SERVICE BULLETIN 105 REVISION A MANDATORY

SUBJECT: Retractable Landing Gear Oleo Strut, Weld Inspection and Repair

APPLICATION: Glasair I and II Retractable Landing Gear, Serial Numbers 071 through 302.

FIGURE (1)

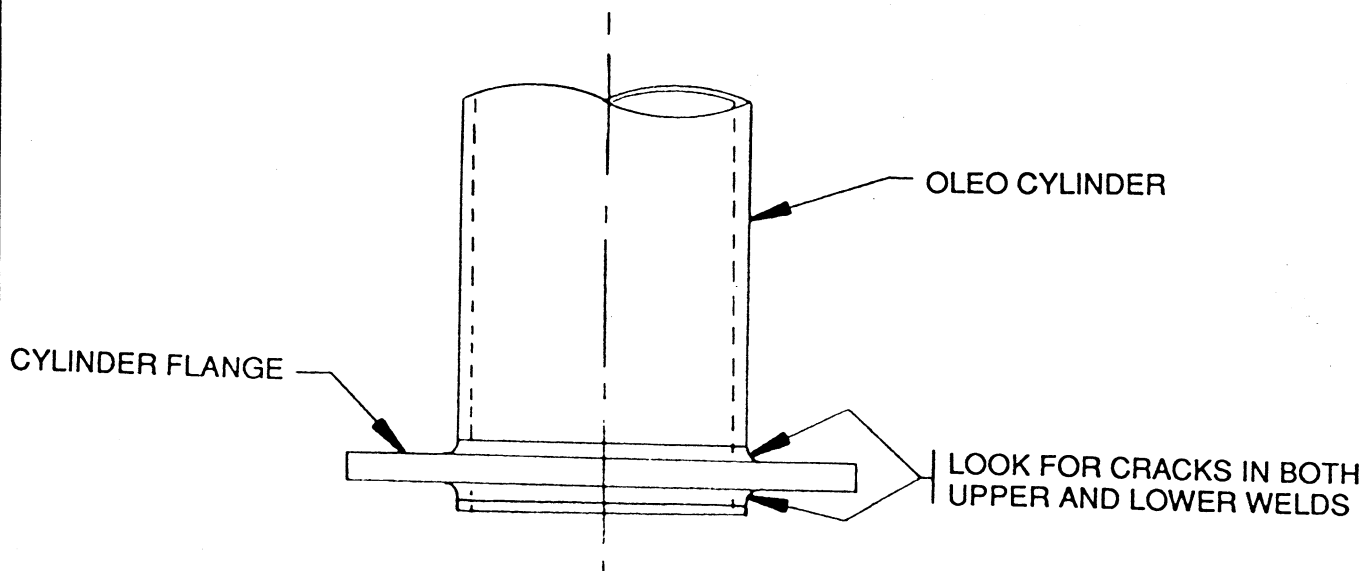
DESCRIPTION: We have received two reports of small cracks found on the upper weld of the chrome oleo cylinder flange on Glasair RG retractable landing gear manufactured by our original subcontractor. X-rays and cross-sectional visual inspections of the cracks have revealed the problem to be a lack of fusion (cold weld) between weld passes. Neither over stress nor fatigue are suspected to be the cause.

If this service bulletin applies to your landing gear, all three struts must be inspected for cracks in both the upper and the lower welds that secure the fork flange to the chrome oleo cylinder. Inspecting the welds requires that the nose gear fork and the main gear half forks be disassembled from the oleo cylinder flanges. If cracks are found, the affected oleo cylinders must be removed from the landing gear struts and repaired by welding.

Using dye penetrant inspection equipment, which should be available at most local FBOs, inspect both the upper and lower welds that join the fork flange to the oleo cylinder on all three struts, as shown in FIGURE (1). If a crack is found in any of the welds, the cylinder must be removed from the oleo strut and returned to Stoddard-Hamilton Aircraft for repair.
